# Glenlee Precinct Rezoning

## RIPARIAN CORRIDOR STUDY

Client: Sada Services Pty Ltd

16-May-2016

Figure 8. Water Cycle Management - Watercourse Classification  
Glenlee Precinct - Proposed Rezoning

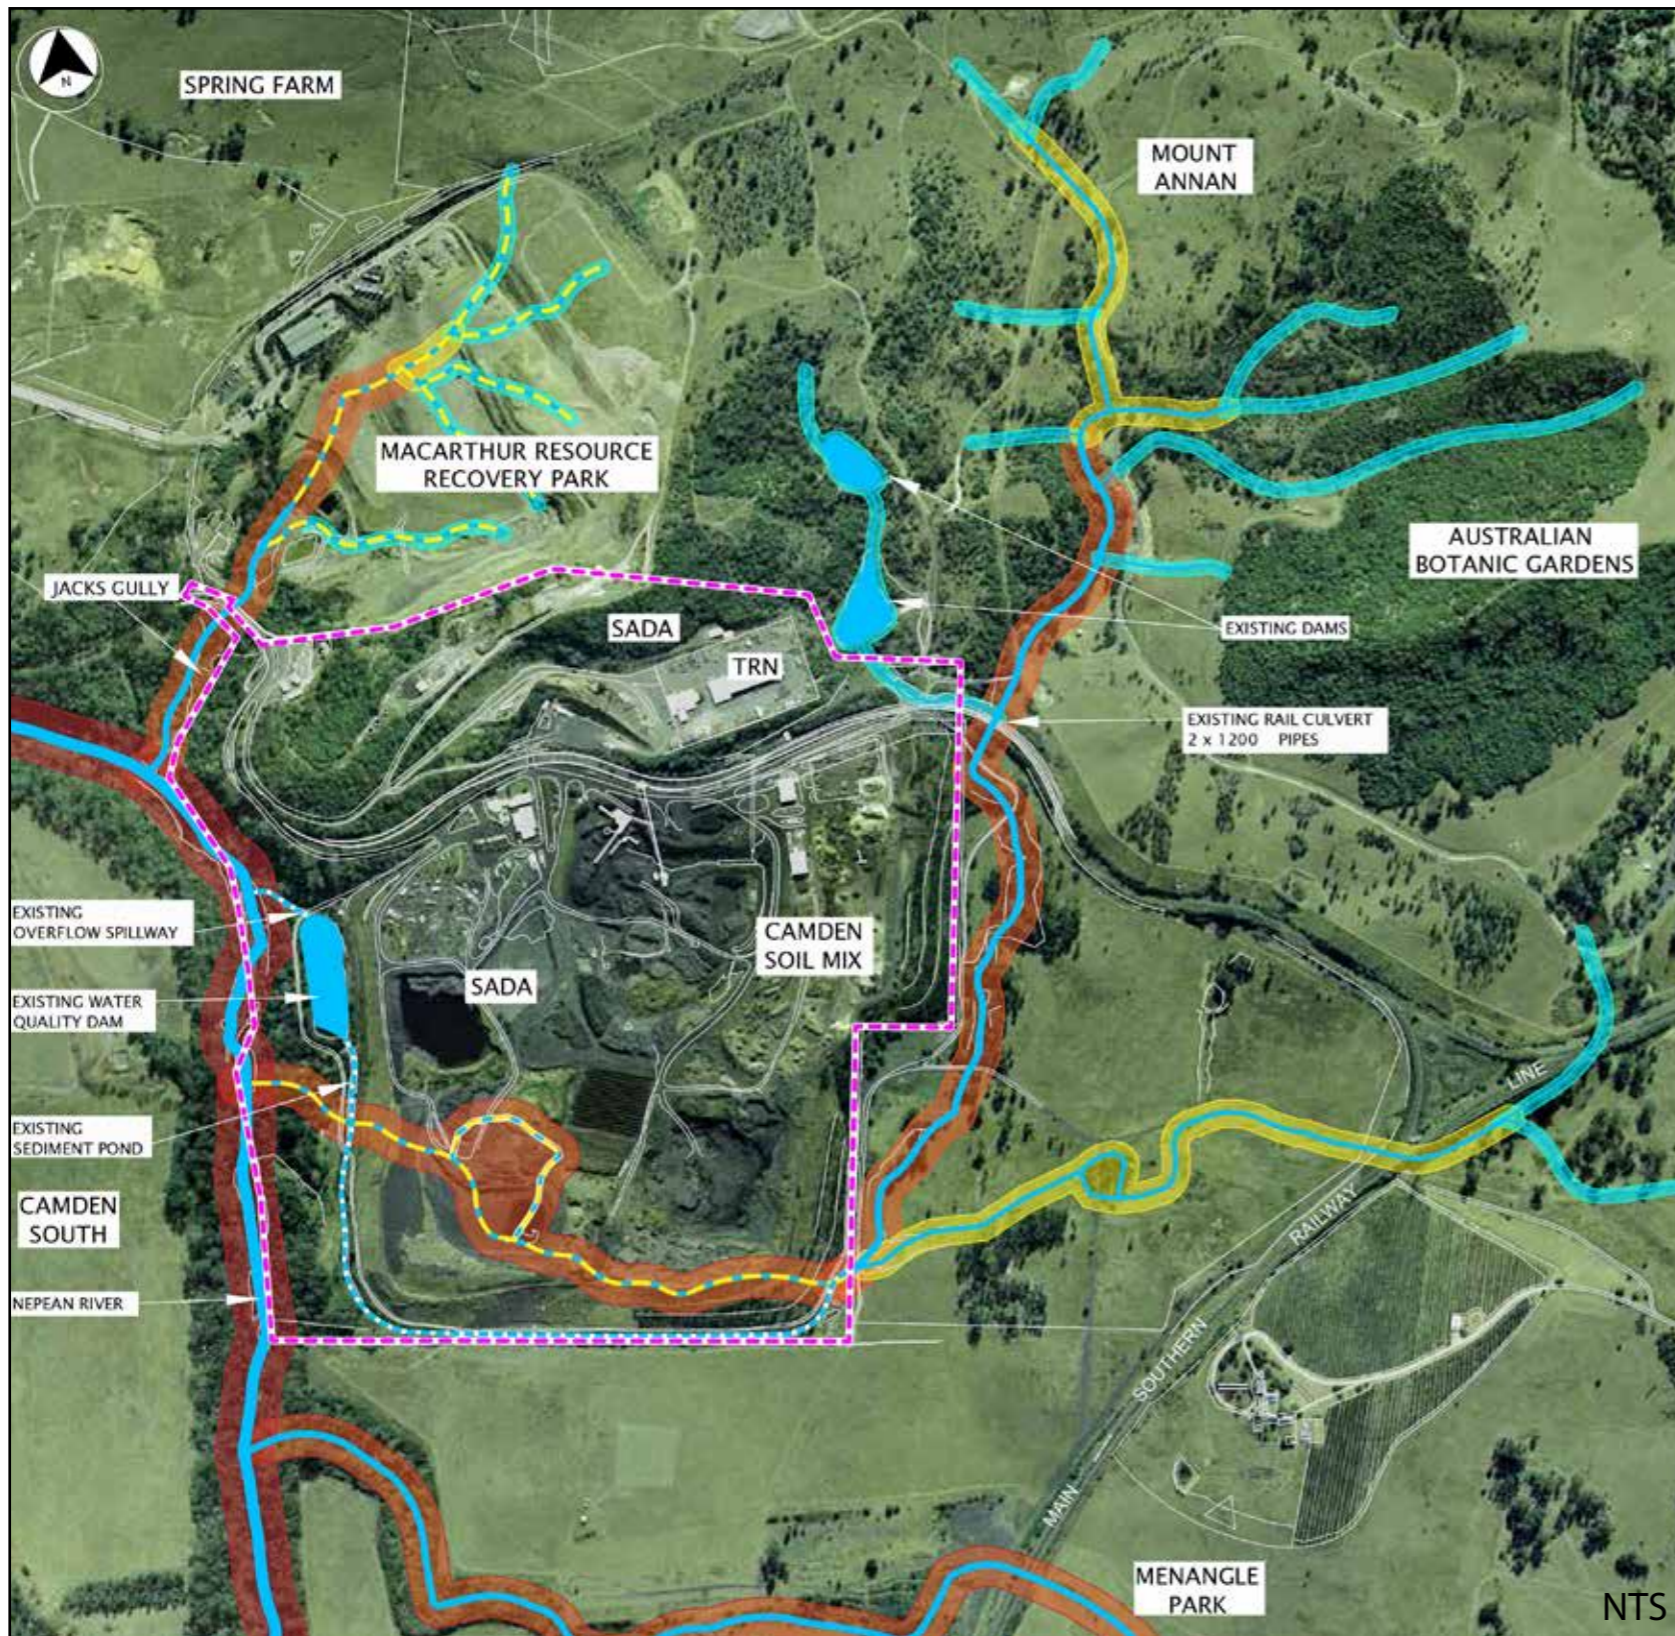
<p>9. Figure 8, This figure shows the Stream Order. While the colours appear logical, the scale widths do not appear representative. This is particularly noticeable for the Nepean River. The Figure should represent these corridors at their scaled widths.</p>	<p>9. Revise Figure 8 to represent corridors at their scaled widths.</p>	<p>9. Given that this is a rezoning proposal, we consider that Figure 8, which is a conceptual representation of the requirements for watercourses, sufficiently conveys the required level of information.</p>	<p>n/a</p>
<p>10. Figure 9 shows the chitter batters. It does not indicate the existing and proposed batter grade. To provide informed comment, this information is necessary.</p>	<p>10. Further details to be provided with Figure 9 with regard to the chitter batters, i.e. indicate the existing and proposed batter grade to allow for further Council comment. .</p>	<p>10. The maximum height of the embankment is around 18-23 m with average side slopes measures to be in the range of 4.5:1 (H:V) on the eastern side, 3.2 -3.7:1 (H:V) on the southern side, and 2.8:1 (H:V) on the western side.</p>	<p>s.2.1.6</p>
